Access Compliance Report

Public Rights-of-Way

(Curb Ramps)

Intersection ID: 16724	Main Street: CHARLOTTE_PARK_DR	Cross Street: PRESSLEY_RD	Location: NW
ADA ID: 900FFB1489FB	Ramp Type: Perp	Initial Pass/Fail: Fail	Overall Compliance: No
Severity Score: 12.5			
Codes/Mitigation Info/Possible Solution		Field Measurements/Component Compliance

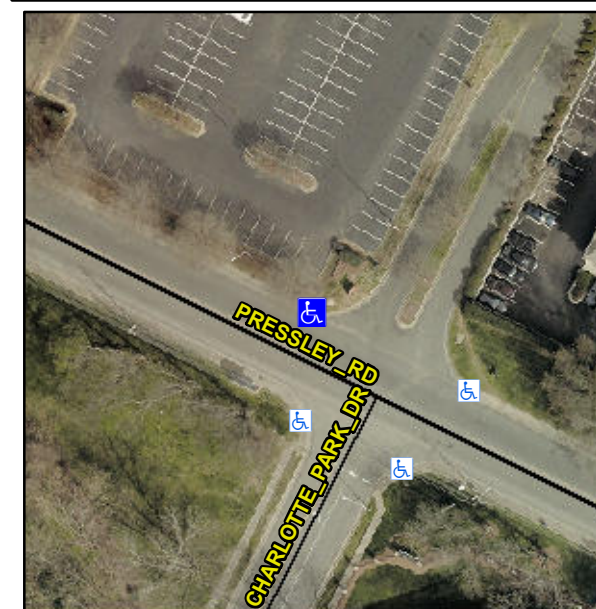
Not Found, R304.2.2

Compliance	Description	Data	Compliance	Description	Data
N/A	Ramp Length (in)	39.0	No	Ramp Slope (%)	9.0
Yes	Ramp Width (in)	60.0	Yes	Ramp XSlope (%)	0.5
N/A	Flare Type LT	N/A	N/A	Flare Type RT	N/A
N/A	Flare Slope LT (%)	N/A	N/A	Flare Slope RT (%)	N/A
N/A	Flare Traversable LT?	N/A	N/A	Flare Traversable RT?	N/A
N/A	Landing Length (in)	N/A	N/A	DWS Provided?	N/A
N/A	Landing Width (in)	N/A	N/A	DWS Contrast?	N/A
N/A	Landing Slope (%)	N/A	N/A	DWS Length (in)	N/A
N/A	Landing X Slope (%)	N/A	N/A	DWS Full Width?	N/A
N/A	Landing Curb? (Y/N)	N/A	N/A	DWS Offset (in)	N/A
N/A	Shared Landing?	N/A			
N/A	Gutter Ponding?	N/A	N/A	Gutter Slope (%)	N/A
N/A	Gutter Lip Ht (in)	2.0	N/A	Gutter X Slope (%)	N/A
N/A	Painted X Walk1?	No	N/A	Painted X Walk2?	N/A
	X Walk 1 Direction	To SW		X Walk 2 Direction	N/A
N/A	X Walk 1 Width (in)	N/A	N/A	X Walk 2 Width (in)	N/A
	X Walk 1 Slope (%)	7.9		X Walk 2 Slope (%)	N/A
	X Walk 1 X Slope (%)	0.3		X Walk 2 X Slope (%)	N/A

Remove & Replace Entire Ramp.
